## **FINAL Staff Report and Notice of Decision**

Riverside Phase IV Neighborhood Park

## Type II Preliminary Site Plan Review, Critical Areas Review, and SEPA MDNS (2020-025-SPR/CAR/SEPA) June 7, 2021

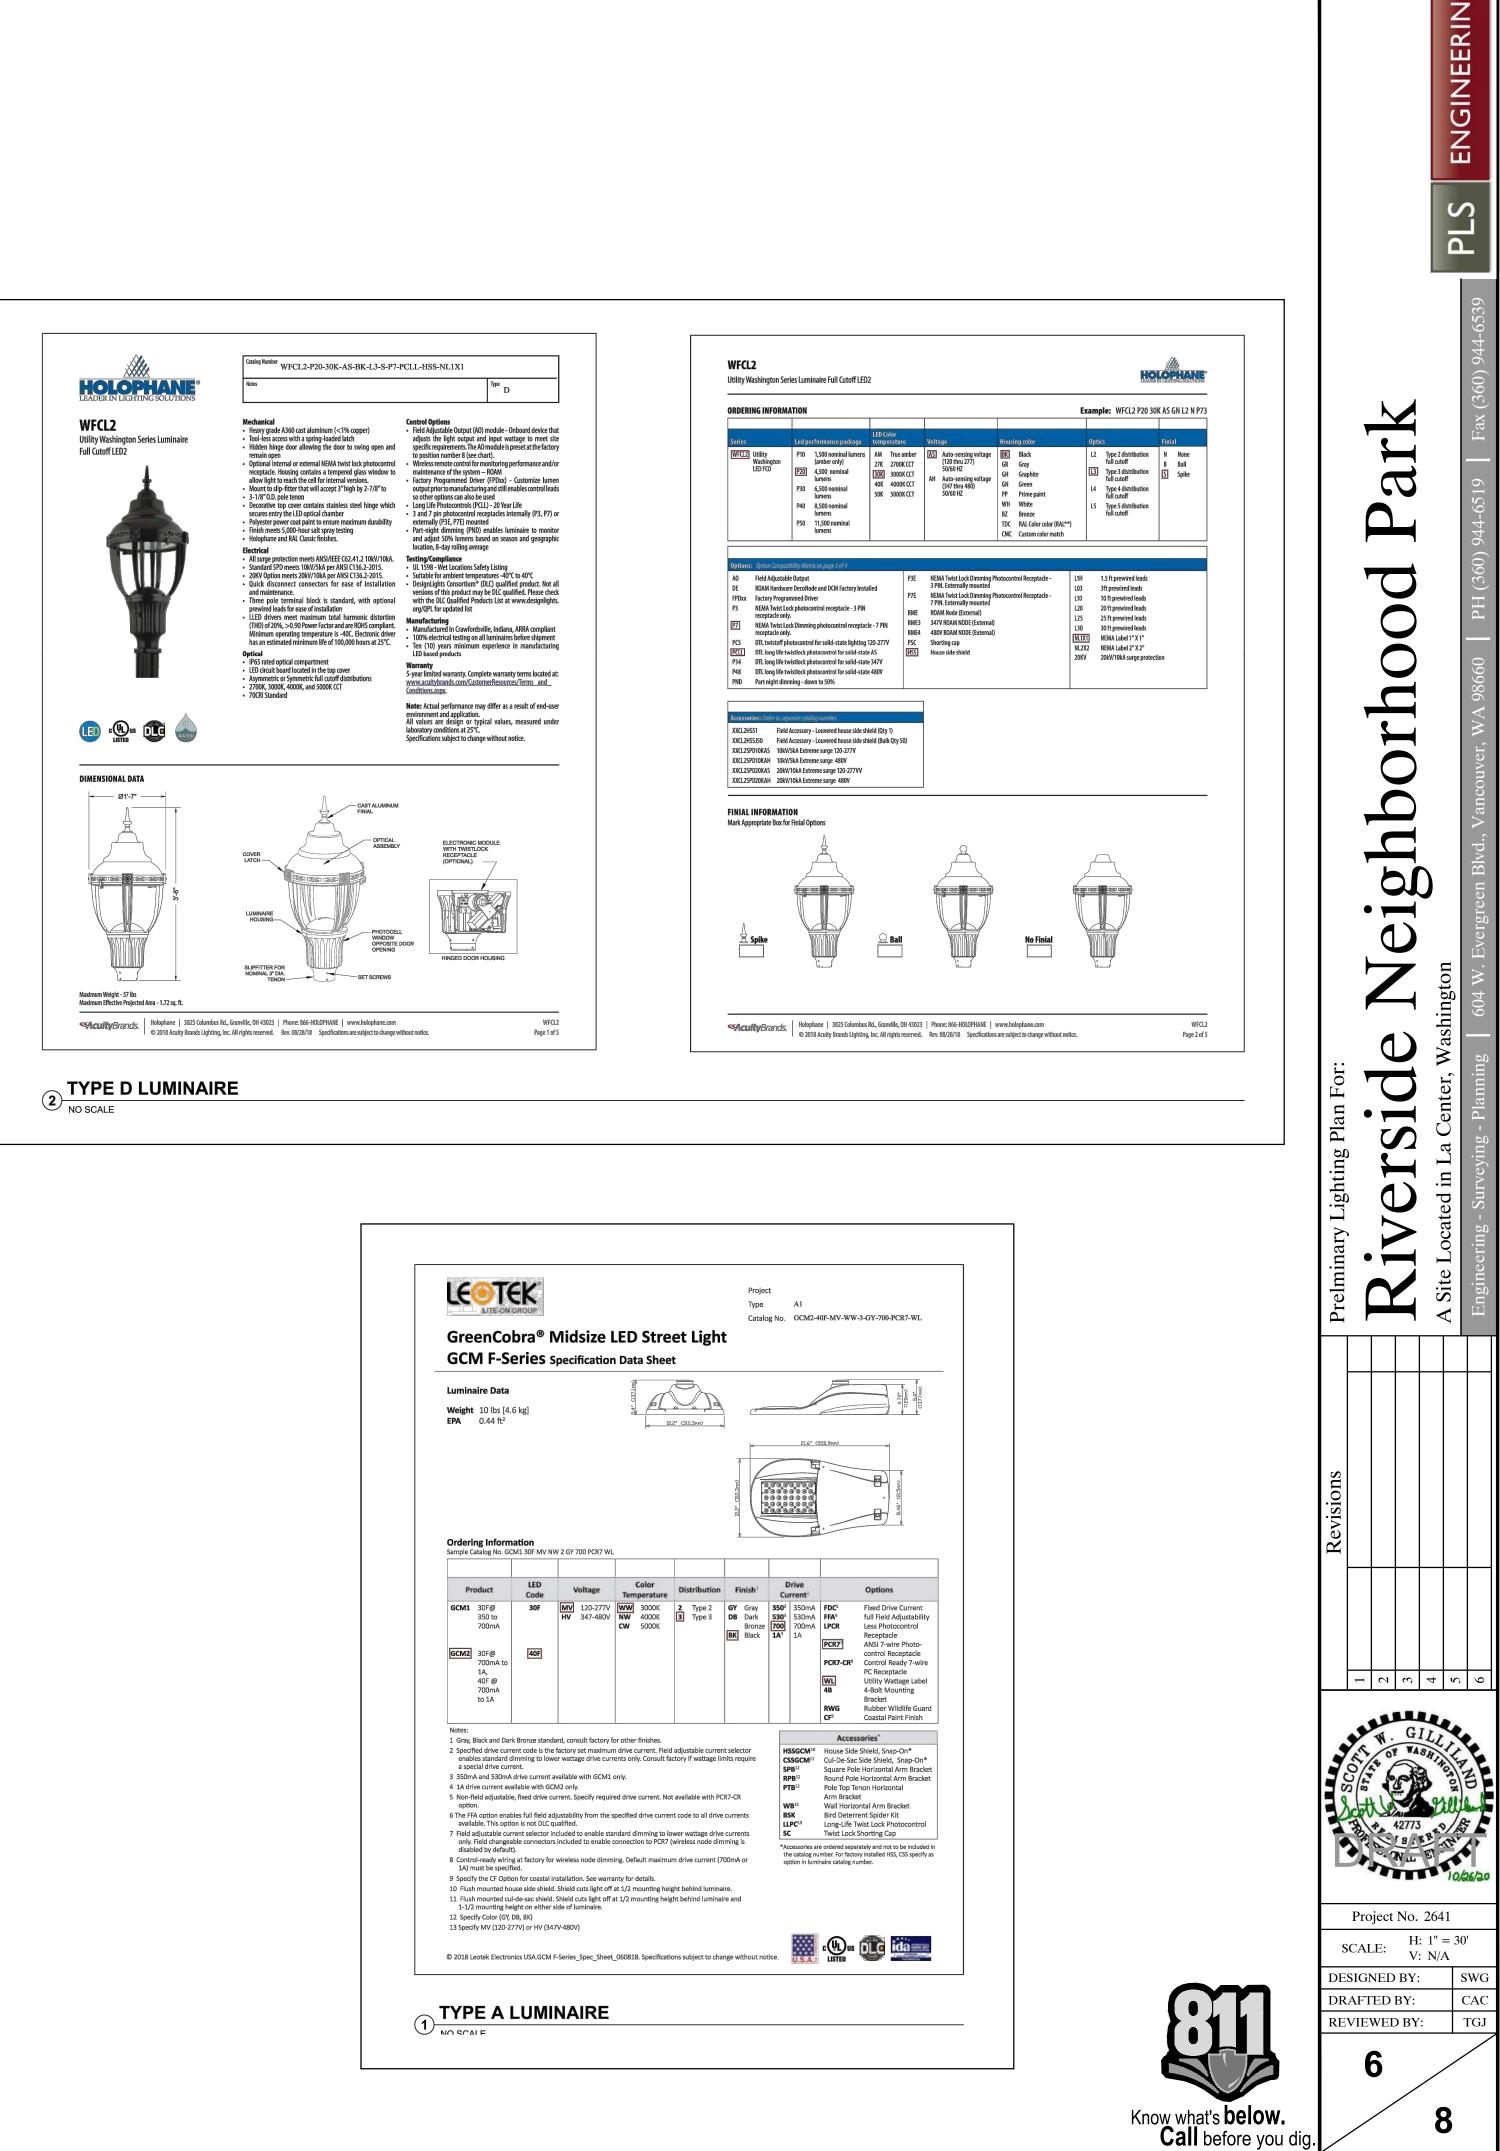
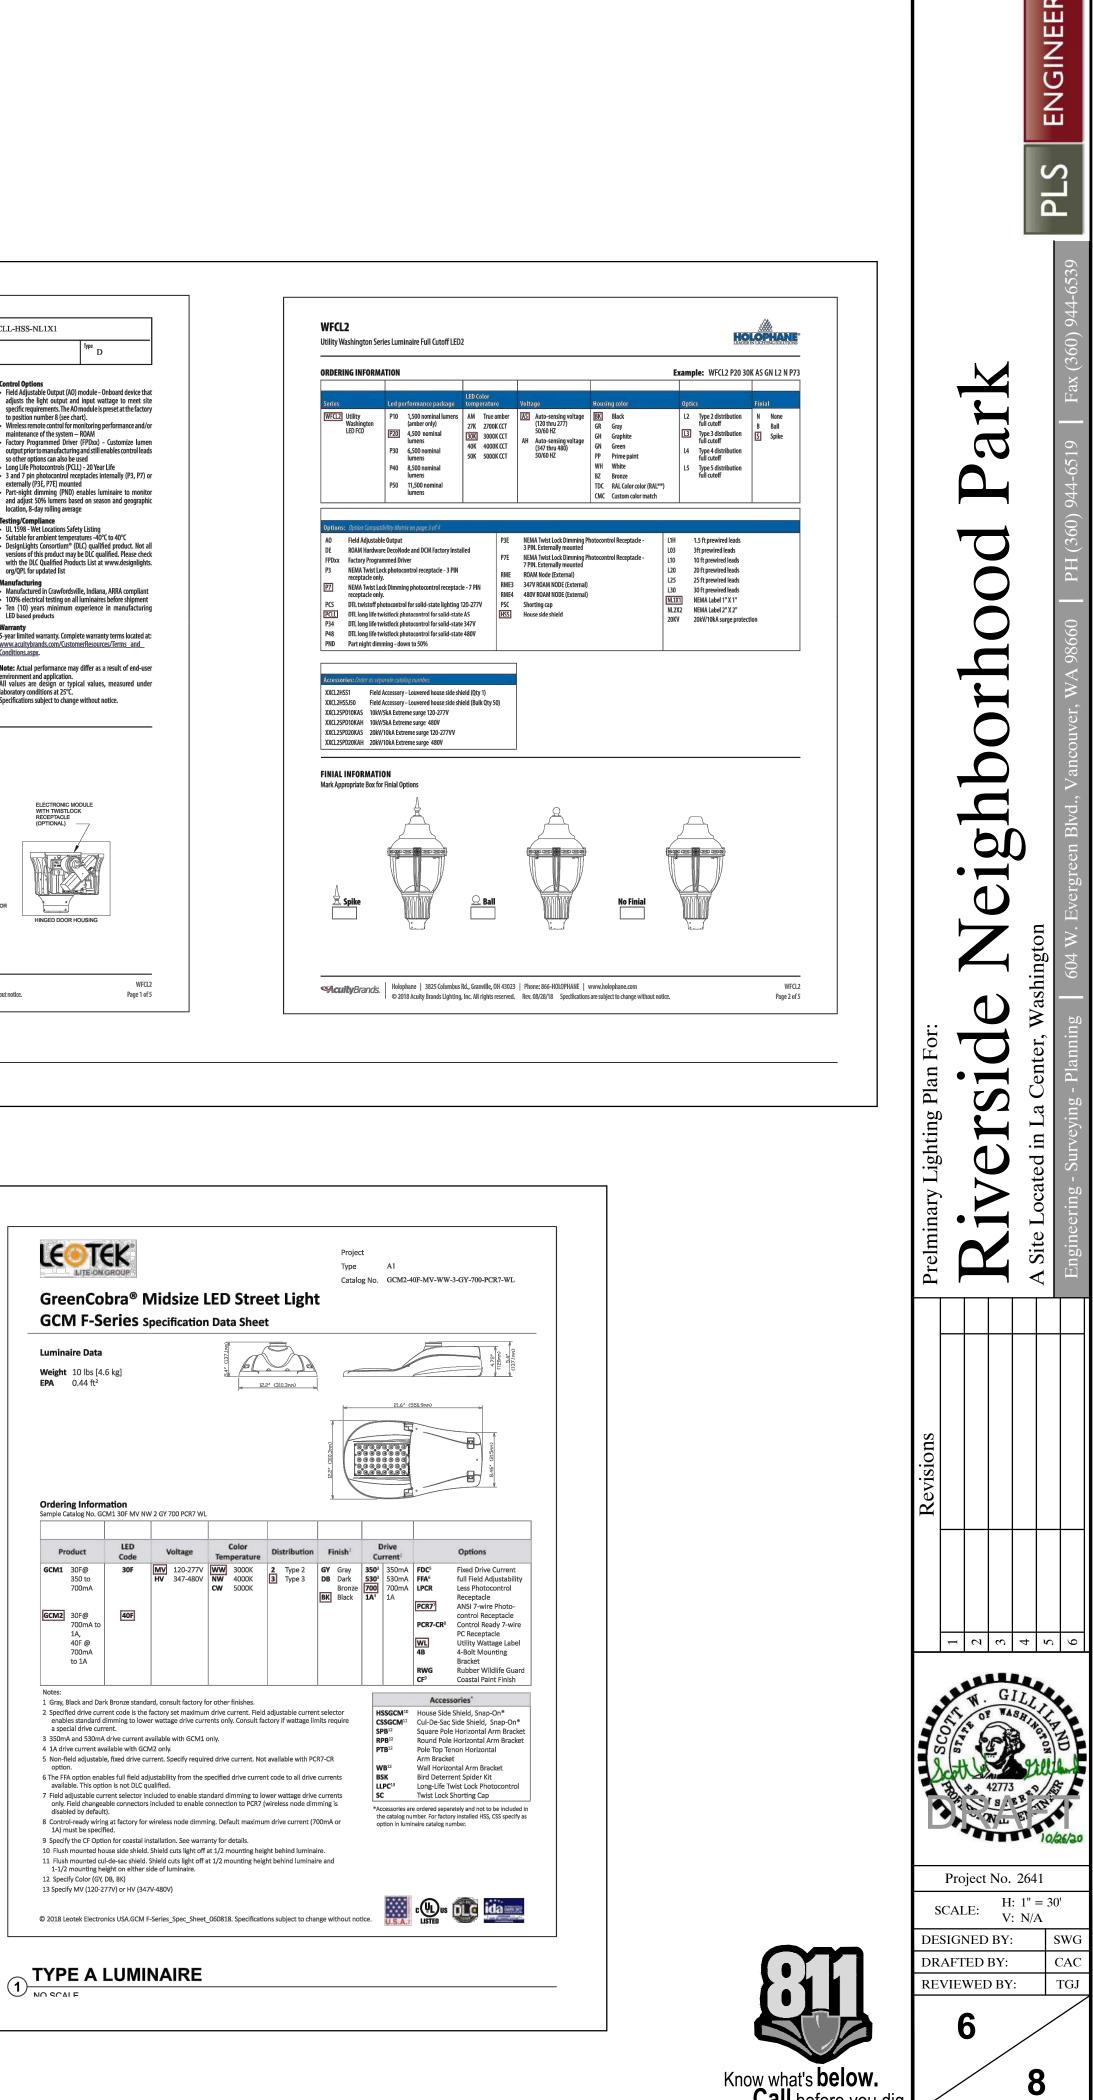
As a **condition of approval,** prior to final site plan approval, the applicant shall provide a final photometric plan and lighting cut sheets that demonstrate compliance with LCMC 18.245.040 and that the required lighting on site does not directly illuminate Wetland A or its buffer.

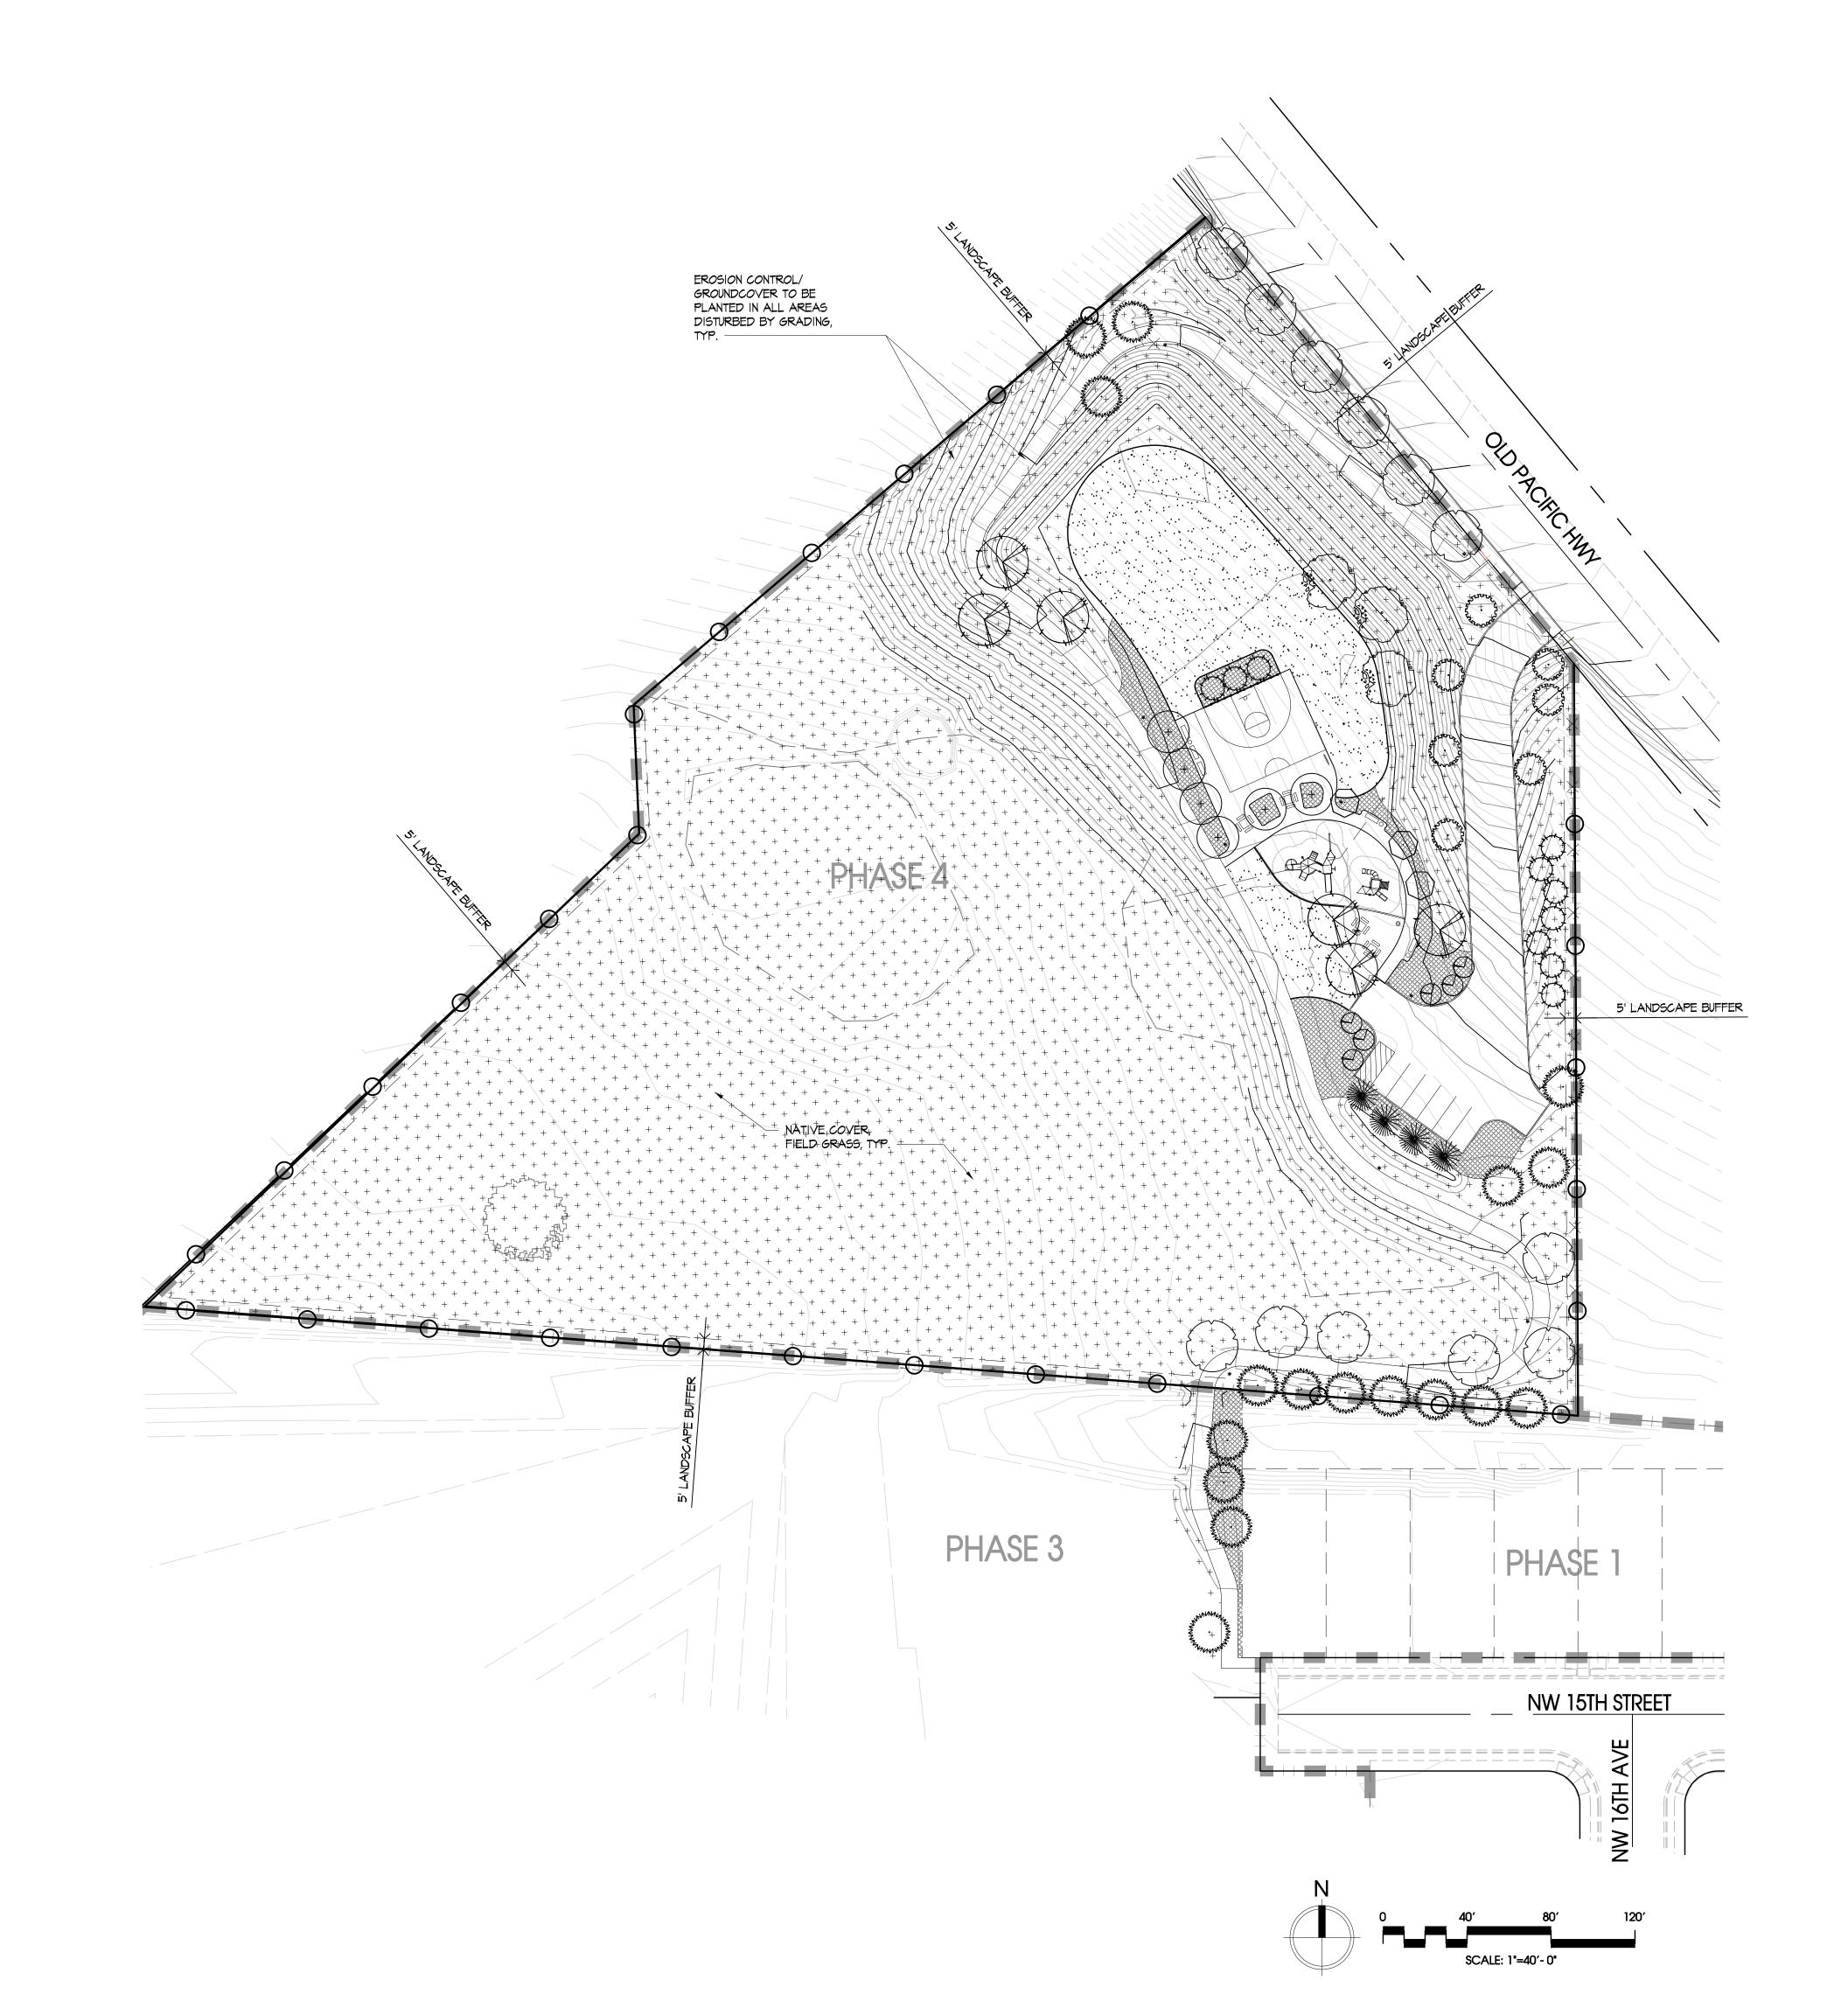
As a **condition of approval**, the applicant's final landscape plan shall show trees spaced every 30 feet behind the fence along Pacific Highway.

As a **condition of approval**, prior to final site plan approval, the applicant shall update their landscape plan to demonstrate compliance with LCMC 18.147.030(1)(b)(x) and fence the park property outside of wetland and buffer areas.

As **a condition of approval**, prior to final site plan approval, the applicant's final landscape plan shall meet the requirements of LCMC 18.245.060(11, 13, and 14).

As **a condition of approval**, plants shall be installed to meet current nursery industry standards and be properly supported and a reference to nursery standards and specifications for support shall be noted on the final landscape plan prior to final site plan approval.
